Access Compliance Report

Public Rights-of-Way

Intersection ID: 10033928	Main Street: PARK_RD	Cross Street: N/A	Location: SE
ADA ID: CBBAFC834EB3	Ramp Type: PerpDiag	Initial Pass/Fail: Fail	Overall Compliance: No
Severity Score: 50			
Codes/Mitigation Info/Possible Solution		Field Measurements/Component Compliance

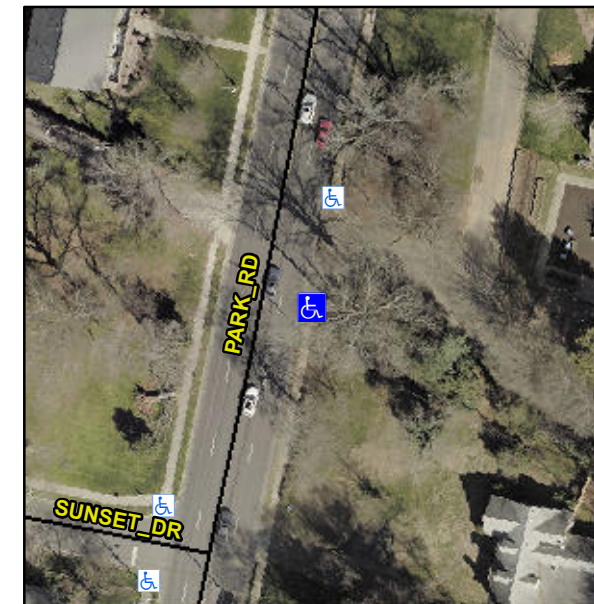
R304.2.2, R304.5.3

Compliance	Description	Data	Compliance	Description	Data
N/A	Ramp Length (in)	48.0	No	Ramp Slope (%)	18.0
Yes	Ramp Width (in)	48.0	No	Ramp XSlope (%)	8.5
N/A	Flare Type LT	N/A	N/A	Flare Type RT	N/A
N/A	Flare Slope LT (%)	N/A	N/A	Flare Slope RT (%)	N/A
N/A	Flare Traversable LT?	N/A	N/A	Flare Traversable RT?	N/A
N/A	Landing Length (in)	N/A	N/A	DWS Provided?	N/A
N/A	Landing Width (in)	N/A	N/A	DWS Contrast?	N/A
N/A	Landing Slope (%)	N/A	N/A	DWS Length (in)	N/A
N/A	Landing X Slope (%)	N/A	N/A	DWS Full Width?	N/A
N/A	Landing Curb? (Y/N)	N/A	N/A	DWS Offset (in)	N/A
N/A	Shared Landing?	N/A			
N/A	Gutter Ponding?	N/A	N/A	Gutter Slope (%)	N/A
N/A	Gutter Lip Ht (in)	N/A	N/A	Gutter X Slope (%)	N/A
N/A	Painted X Walk1?	No	N/A	Painted X Walk2?	No
	X Walk 1 Direction	To NE		X Walk 2 Direction	To NW
N/A	X Walk 1 Width (in)	N/A	N/A	X Walk 2 Width (in)	N/A
	X Walk 1 Slope (%)	4.3		X Walk 2 Slope (%)	3.7
	X Walk 1 X Slope (%)	13.7		X Walk 2 X Slope (%)	2.2

N/A	Ramp inside XWalk1?	N/A	N/A	Ramp inside XWalk2?	N/A
	Road Slope (%)	2.2	N/A	Clear Space?	N/A
	Road X Slope (%)	13.3	N/A	Clear Space to XWalk (in)	N/A
N/A	Any Obstructions?	N/A	N/A	Storm Grate/Utility Hazard?	N/A
	Obstruction Type			Storm Grate/Utility Type	
		N/A			N/A
			Yes	Surface Condition? (G/P)	Good

Remove & Replace Curb Ramp With Two New Directional Ramps or Equivalent.
